Request Summary

- Requesting approval of Conditional Use, FDP, Design Review, and Variances to develop a Sheetz gas station with a food service drive-thru
 - Zoned NC – Neighborhood Commercial
 - Gasoline Service Stations and Eating Places with Drive-Thru Facilities are conditionally-permitted uses
- Land Use Plan designates property as Community Commercial in the North Gateway Focus Area
 - Intended for medium to large scale uses that serve the larger area
 - Encourages a mix of uses to increase connectivity between uses
- Combining 3 parcels, totaling 4.19 acres
 - Frontage on Morse Road and Johnstown Road

Gahanna

Site Plan & Landscaping

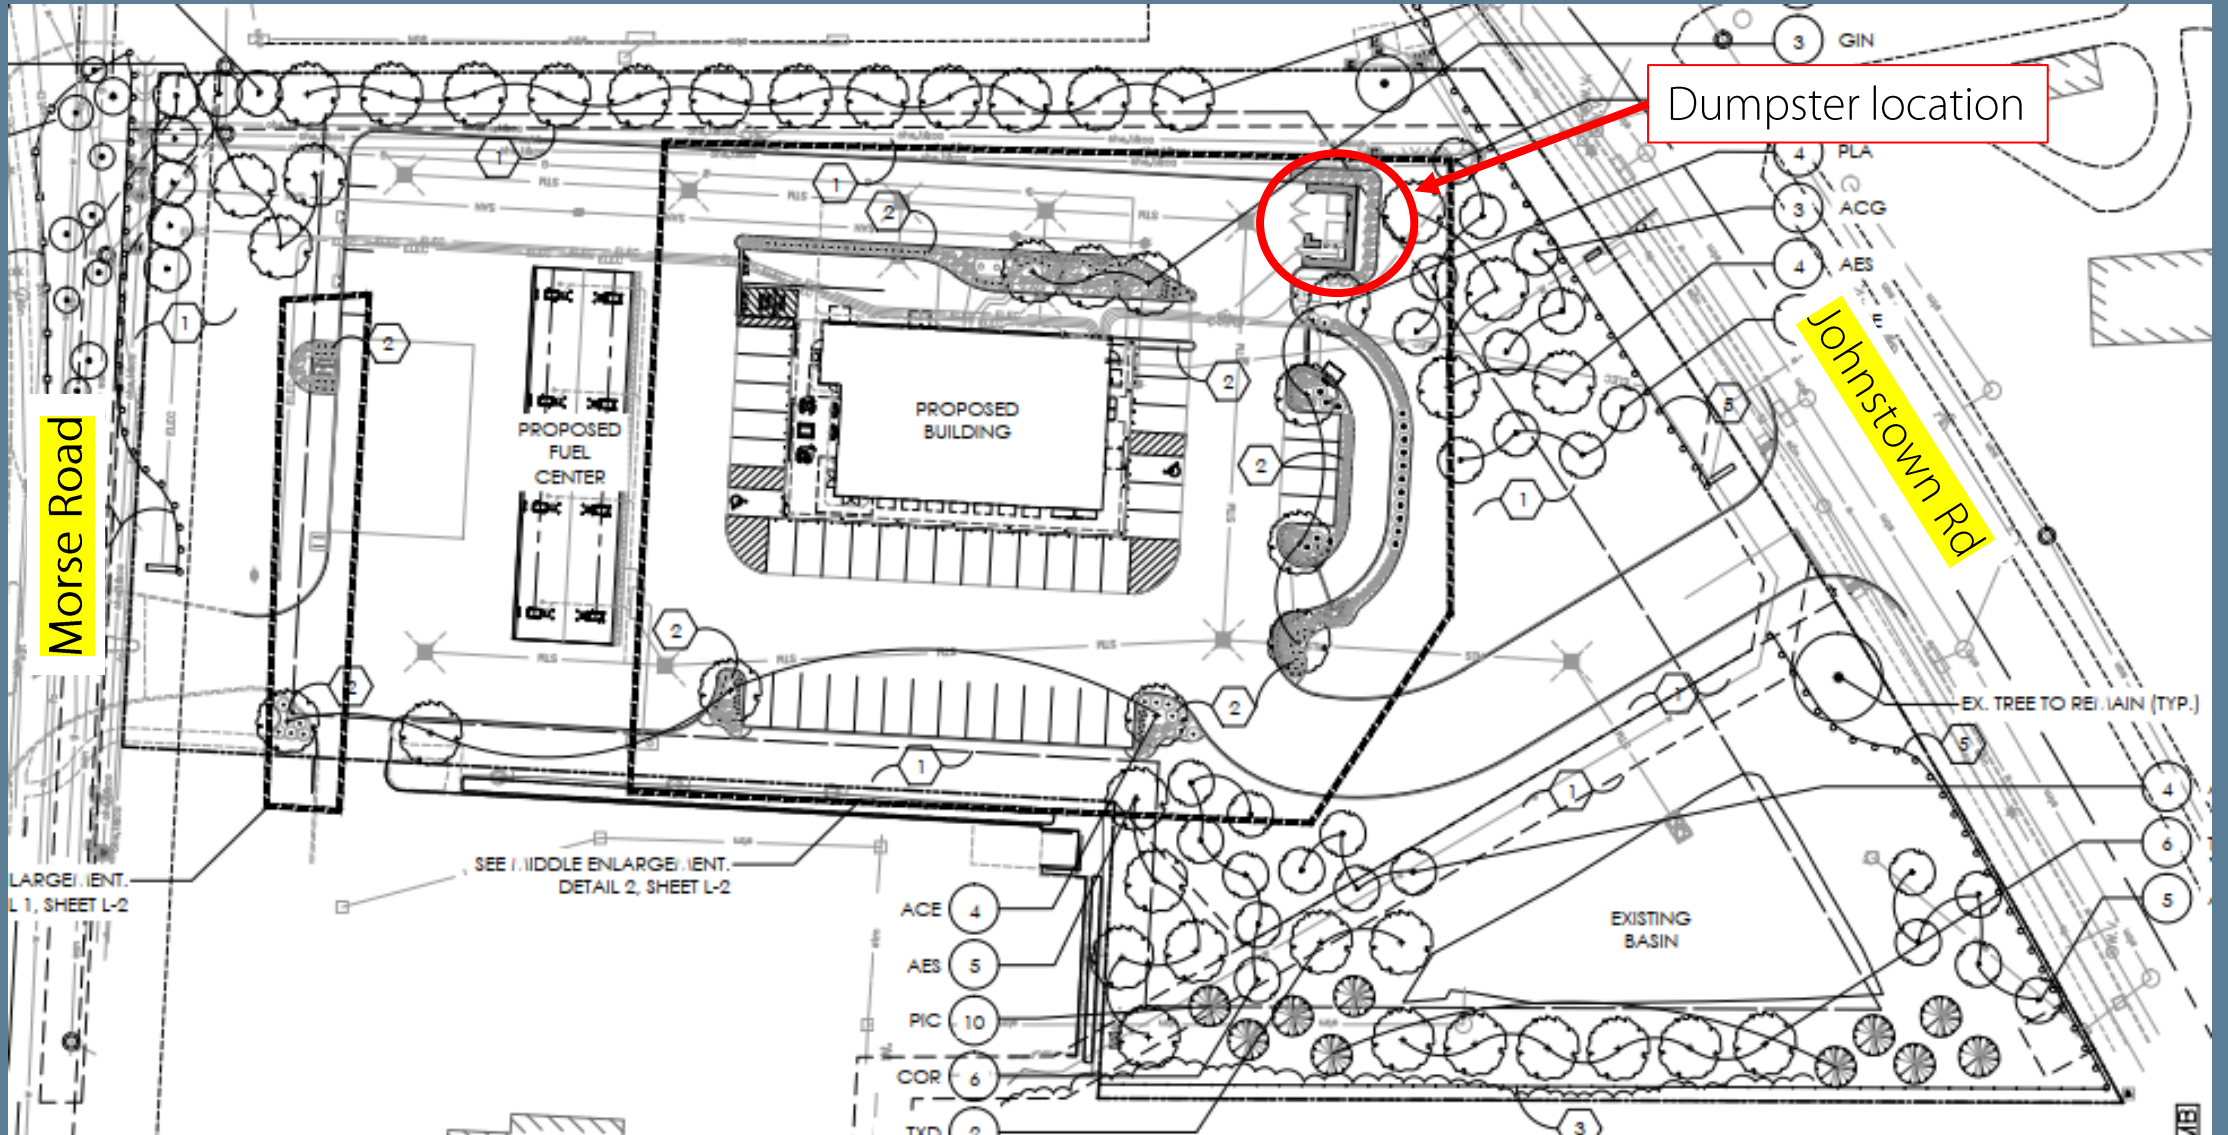
1. Dumpsters are required to be located to the rear of the building
 - With frontage on north and south ends of property, a rear yard does not exist
 - Property lacks compliant location for dumpster
 - To be located 60 feet from Johnstown Road and screened by 5-foot fence and cluster of shade trees
2. Required amount of interior landscaping shall be 5% of the total area of parking lot pavement.
 - 37 trees required in interior parking lot in islands/peninsulas
 - 11 trees proposed in interior lot
 - 86 new trees proposed for entire site in addition to trees being preserved
 - Meets intent of landscaping requirement

Site Plan & Landscaping

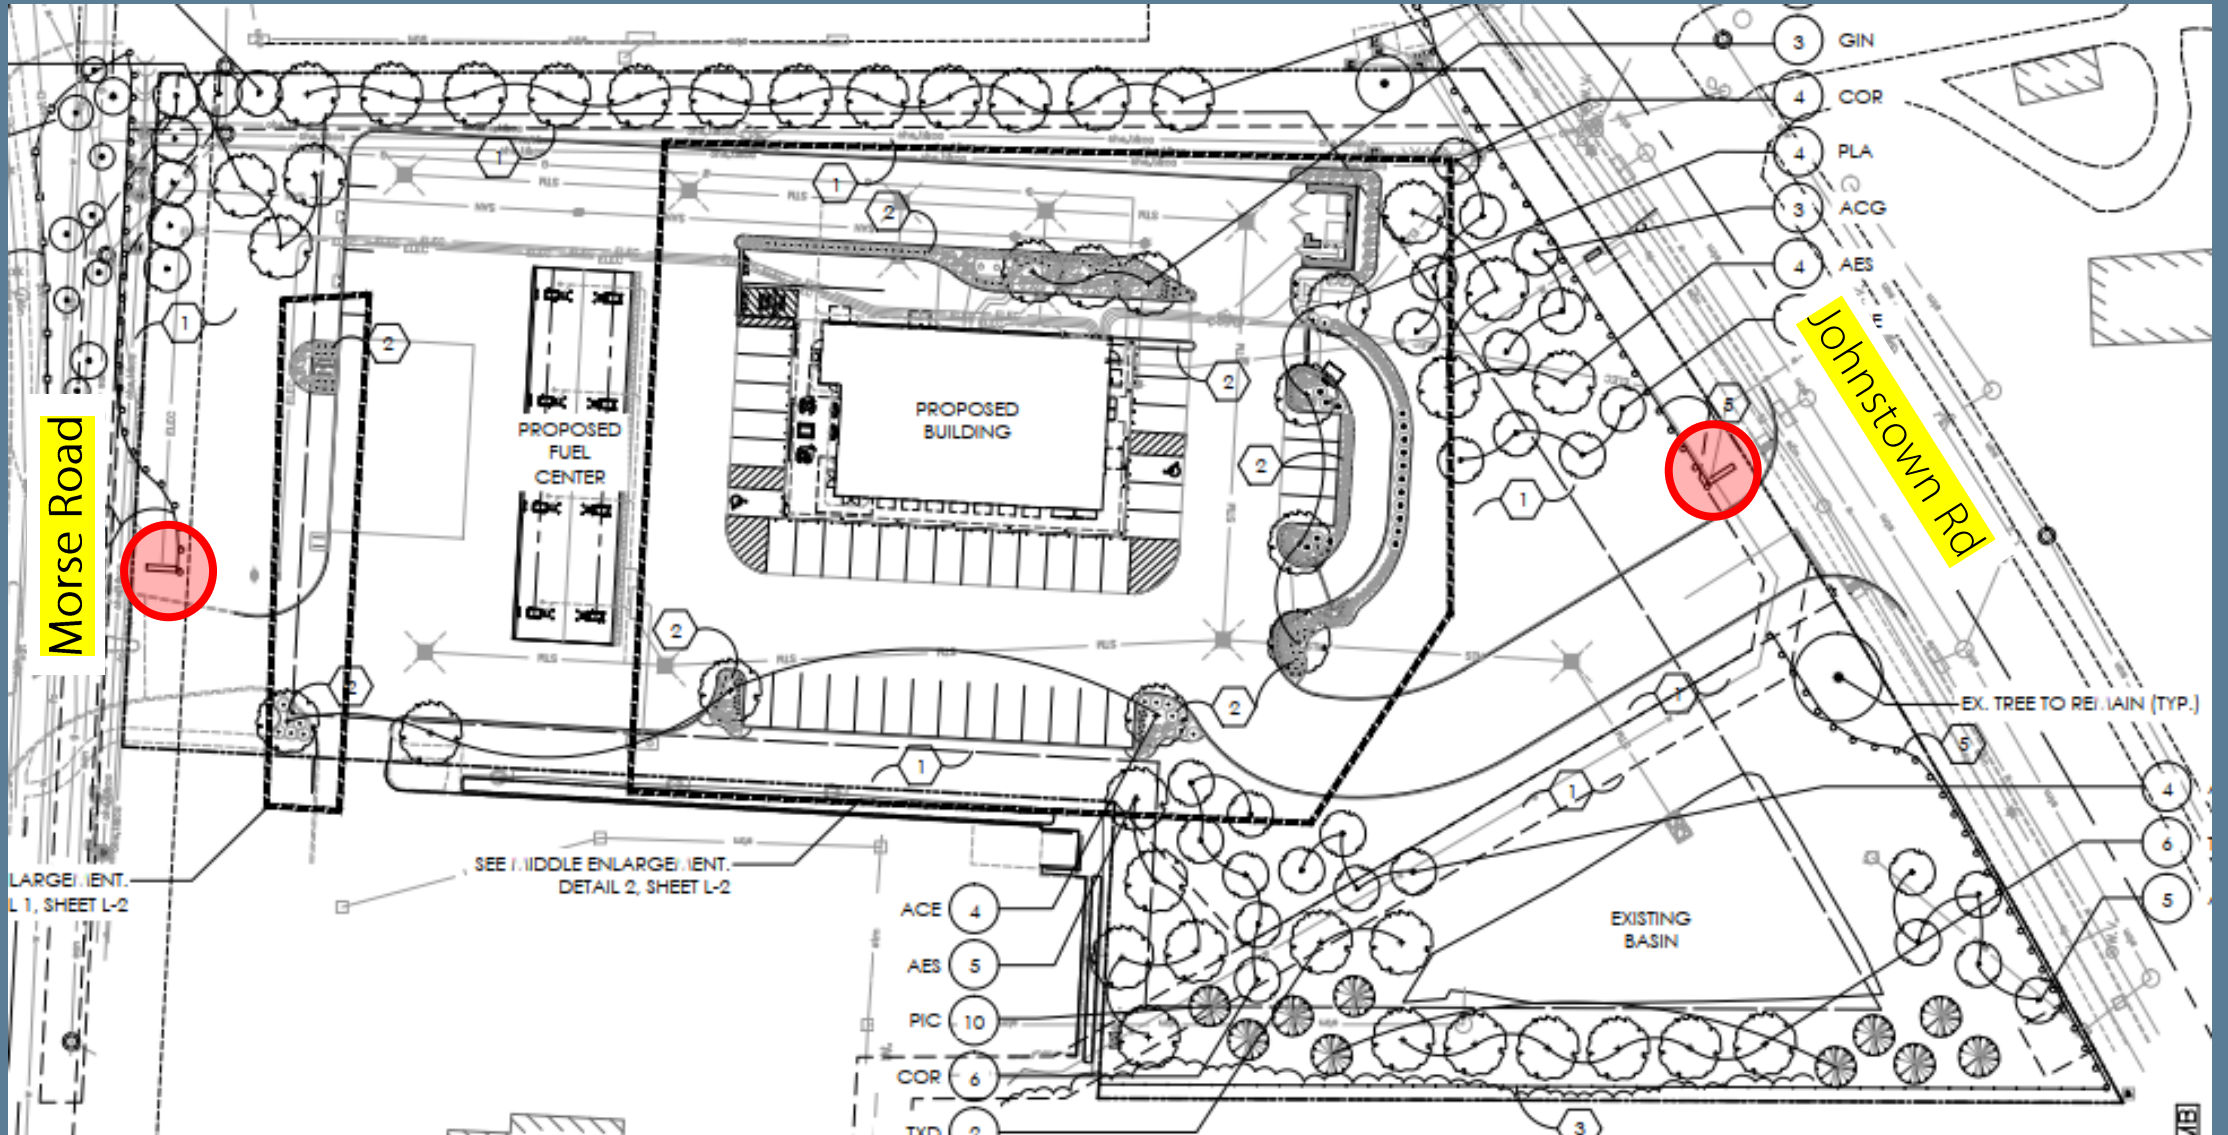
- Staff does not support variance requested for reduced setback and reduced landscaping for the ground signs along Morse Rd and Johnstown Rd
 - Reasons for needing variances are not provided
 - Not aware of similar variances being granted
 - Concerns of traffic obstruction by placing signs closer to right-of-way (5 ft)
